PERMIT

SEWAGE DISPOSAL SYSTEM

MARYLAND STATE DEPARTMENT OF HEALTH*

Property known as #4402 ROUTE 97
 MAUREEN T. CLARKE-DEED 904/02B
 4TH ELECTION DIST. HOWARD CO. MD

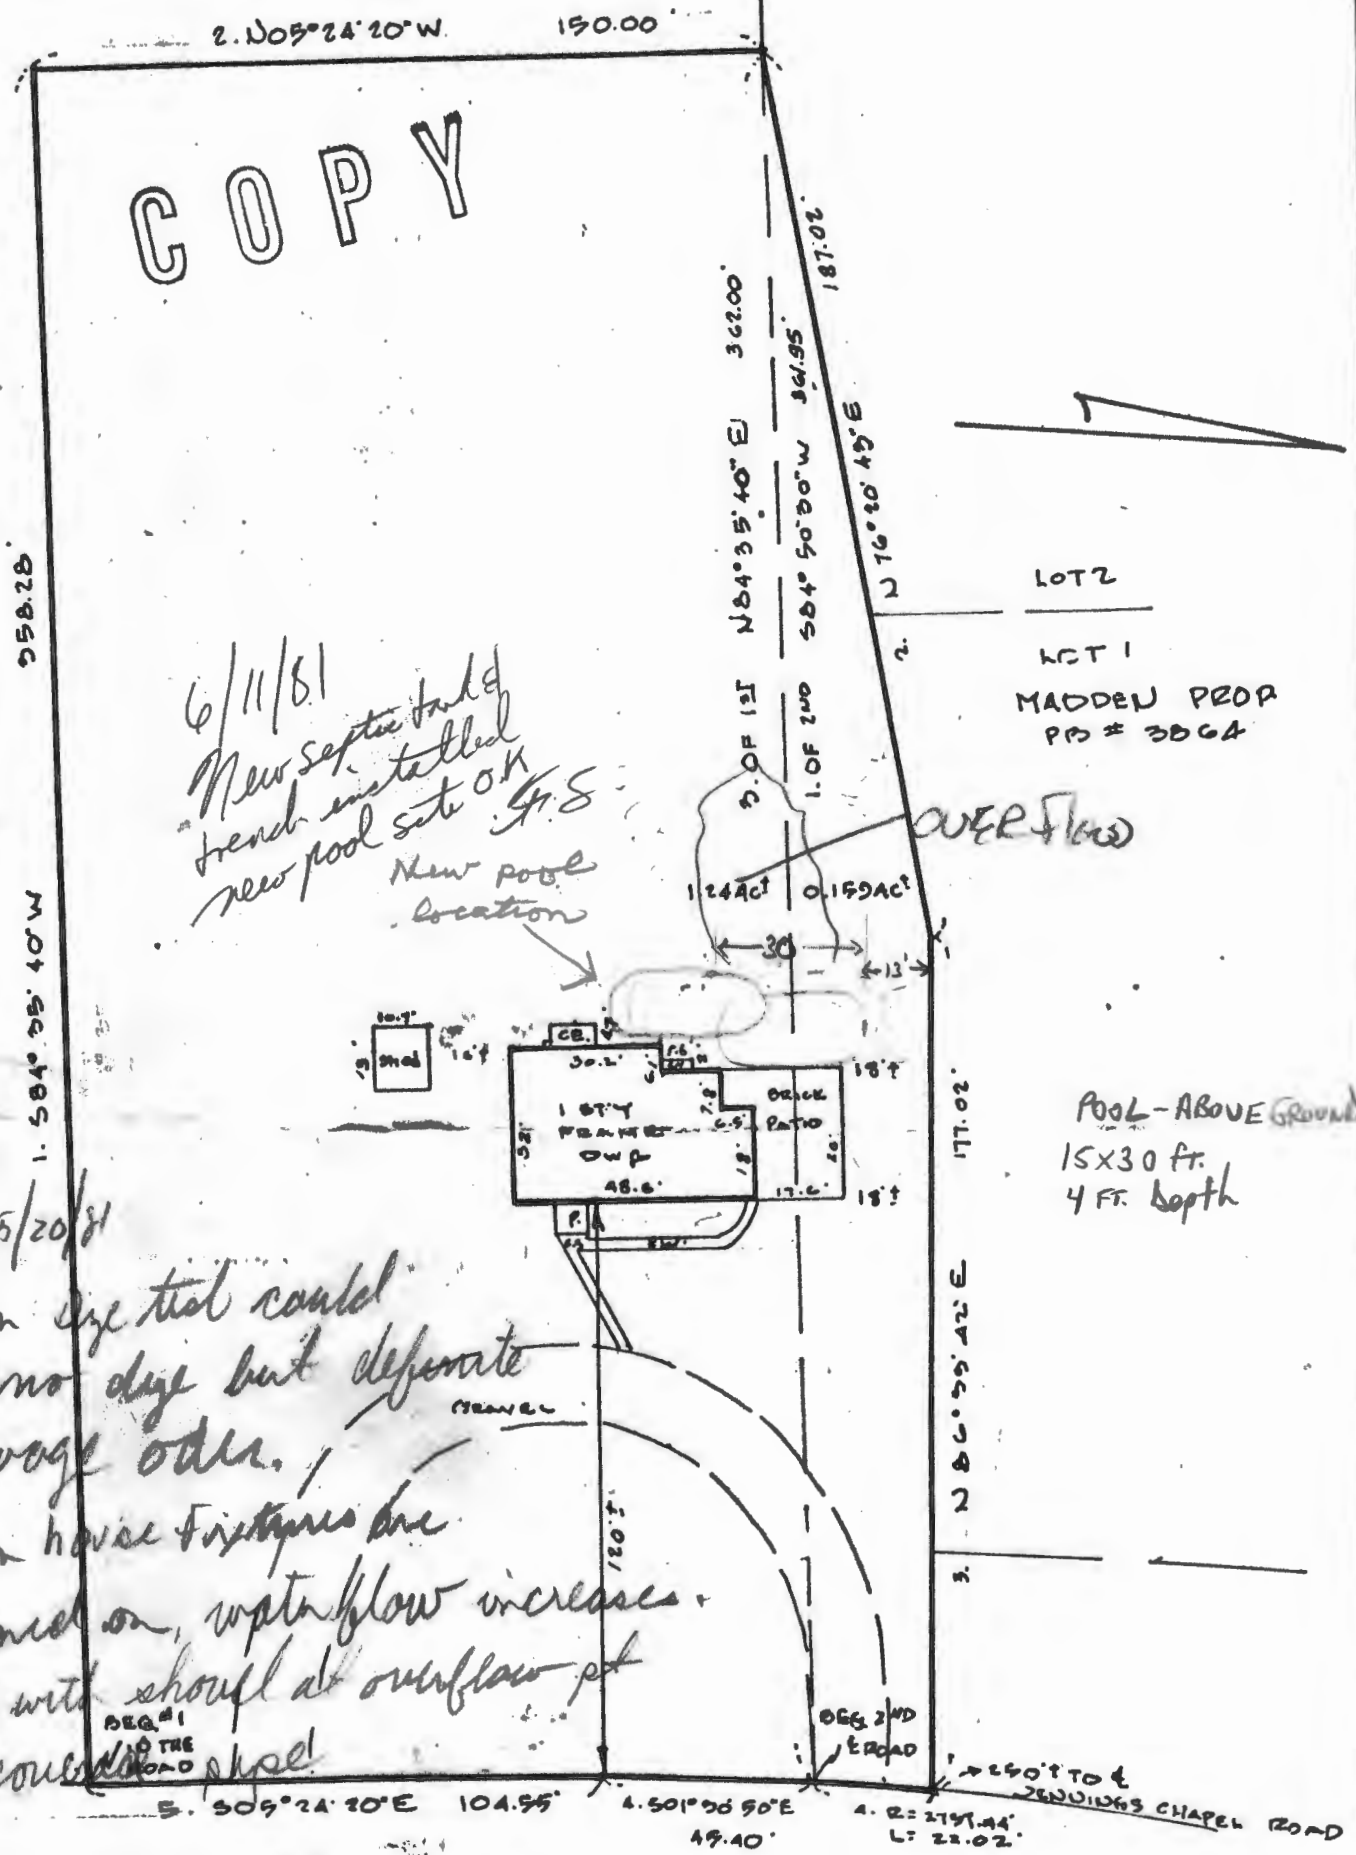
6/11/81
 New septic tank
 trench installed
 new pool site OK
 New pool location

SE 5/20/81
 Run eye trial could
 see no dye but definite
 sewage odor.
 when house fixtures are
 turned on, water flow increases.
 Dig with shovel at overflow pt
 discovered pipe!

recommend the repair system. New septic tank, 70 ft
trench. Inlets 4 ft, max depth 11 ft. with 7 ft of
stone. Fill in old concrete block pits.
